GAGE ESTATES SUBDIVISION

Engineering Comments: FINAL PLAT COMMENTS (should be addressed prior to submitting the FINAL PLAT for review and/or signature by the City Engineer):

APPLICATION NUMBER 5 DATE January 6, 2022

DETAIL SITE PLAN

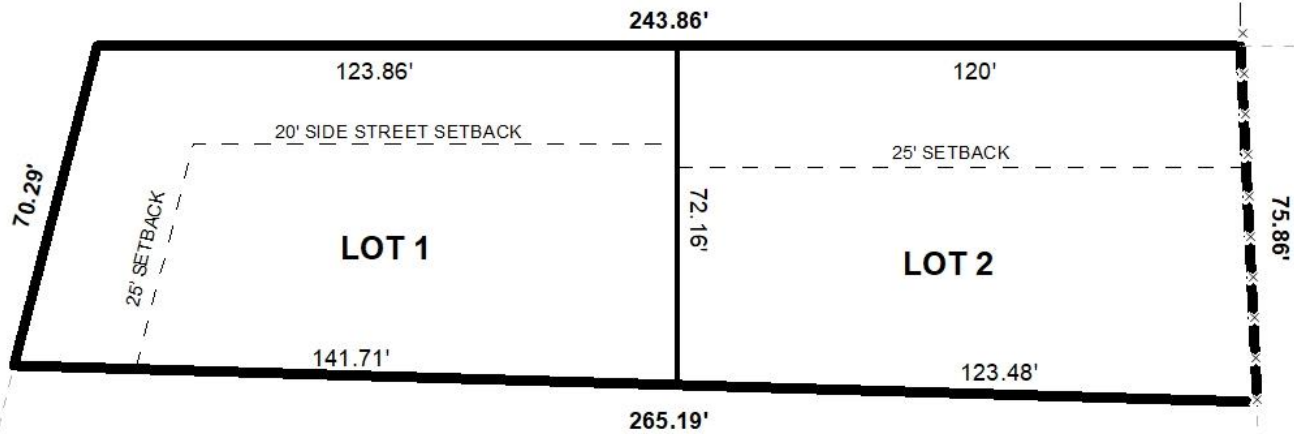
The subject site has frontage on Dauphin Island Parkway and Stewart Road. Dauphin Island Parkway is a component of the Major Road Plan with a planned 100-foot right-of-way. As the preliminary plat indicates a right-of-way width of 53-feet from the centerline of Dauphin Island Parkway, no dedication would be required along Dauphin Island Parkway. Stewart Road is a minor street with curb and gutter, and with a compliant 60-foot right-of-way. Therefore, no dedication would be required along Stewart Road. The right-of-way widths of both streets should be retained on the Final Plat, if approved. A 25-foot radius curve dedication should be required at the intersection of Dauphin Island Parkway and Stewart Road.

As on the preliminary plat, the 25-foot minimum building setback line should be retained on the Final Plat along Dauphin Island Parkway for Lot 1, and along Stewart Road for Lot 2. The 20-foot minimum building setback line along Stewart Road for Lot 1 is permissible along a side street via the regulations of the Zoning Ordinance. The proposed lots meet the minimum size requirements of the Subdivision Regulations. As on the preliminary plat, the lot size labels in both square feet and acres should be retained on the Final Plat, revised for any dedication (radius), or a table should be furnished on the Final Plat providing the same information.

A dwelling currently exists on proposed Lot 2. As this is not indicated on the preliminary plat, the dwelling's Western extremities should be illustrated on the Final Plat to ensure setback compliance from the new interior property line.

As per the Traffic Engineering comments, the driveway number, size, location, and design are to be approved by Traffic Engineering and conform to AASHTO standards. A note should be required on the Final Plat stating these comments.

- 1) retention of the right-of-way widths of Dauphin Island Parkway and Stewart Road on the Final Plat;
- 2) dedication to provide a 25-foot radius curve at the intersection of Dauphin Island Parkway and Stewart Road;
- 3) retention of the 25-foot minimum building setback line along Dauphin Island Parkway for Lot 1, and along Stewart Road for Lot 2;
- 4) retention of the 20-foot minimum building setback line along Stewart Road for Lot 1 on the Final Plat;
- 5) retention of the lot size labels in both square feet and acres on the Final Plat, revised for any required dedication (radius), or the furnishing of a table on the Final Plat providing the same information;

- 6) illustration of the existing dwelling's Western extremities on Lot 2 to ensure setback compliance from the new interior property line;
- 7) compliance with the Engineering comments: (FINAL PLAT COMMENTS (should be addressed prior to submitting the FINAL PLAT for review and/or signature by the City Engineer): A. Provide all of the required information on the SUBDIVISION PLAT (i.e. signature blocks, signatures, certification statements, written legal description, required notes, legend, scale, bearings and distances) that is required by the current Alabama State Board of Licensure for Professional Engineers and Land Surveyors. B. Check the POB reference and label. Is the POB a monument that was set as indicated by the LEGEND? C. Add the various labels to the LEGEND. D. Dedicate the corner radius (25' minimum or as approved by the City Engineer and Traffic Engineer) at the northwest corner of LOT 1 to the City of Mobile, and list the amount of dedicated acreage. E. Provide the Surveyor's and Owner's (notarized) signatures F. Add a note to the SUBDIVISION PLAT stating that as shown on the 1984 aerial photo (FLIGHT 28 - #86) LOTS 1 and 2 will receive historical credit of existing (1984) impervious area towards stormwater detention requirement per Mobile City Code, Chapter 17, Storm Water Management and Flood Control) as follows: LOT 1 – NONE and LOT 2 – 1,400 sf. G. Add a note that a Land Disturbance permit will be required for any land disturbing activity in accordance with Mobile City Code, Chapter 17, Storm Water Management and Flood Control); the City of Mobile, Alabama Flood Plain Management Plan (1984); and, the Rules For Erosion and Sedimentation Control and Storm Water Runoff Control. H. Add a note that the approval of all applicable federal, state, and local agencies (including all storm water runoff, wetland and floodplain requirements) will be required prior to the issuance of a Land Disturbance permit. I. Add a note that sidewalk is required to be constructed, and/or repaired, along the frontage of each lot, or parcel, at time of new development or construction, unless a sidewalk waiver is approved. J. Add a note that all existing and proposed detention facilities, common areas, and wetlands shall be the responsibility of the Property Owner(s), and not the responsibility of the City of Mobile. K. Add a note that all easements shall remain in effect until vacated through the proper Vacation process. L. Email a pdf copy of the FINAL SUBDIVISION PLAT and LETTER OF DECISION to the Permitting Engineering Dept. for review at land.disturbance@cityofmobile.org prior to obtaining any signatures. No signatures are required on the drawing. M. After addressing all of the FINAL SUBDIVISION PLAT review comments provide the ORIGINAL (with all signatures except for the Planning Commission, Traffic Engineering, and City Engineer), one (1) copy, and a transmittal letter to the Engineering Permitting Department. They can be dropped off at 205 Government St. or mailed to PO Box 1827, Mobile, AL, 36633.);

- 8) placement of a note on the Final Plat stating the Traffic Engineering comments: (Driveway number, size, location, and design to be approved by Traffic Engineering and conform to AASHTO standards.);
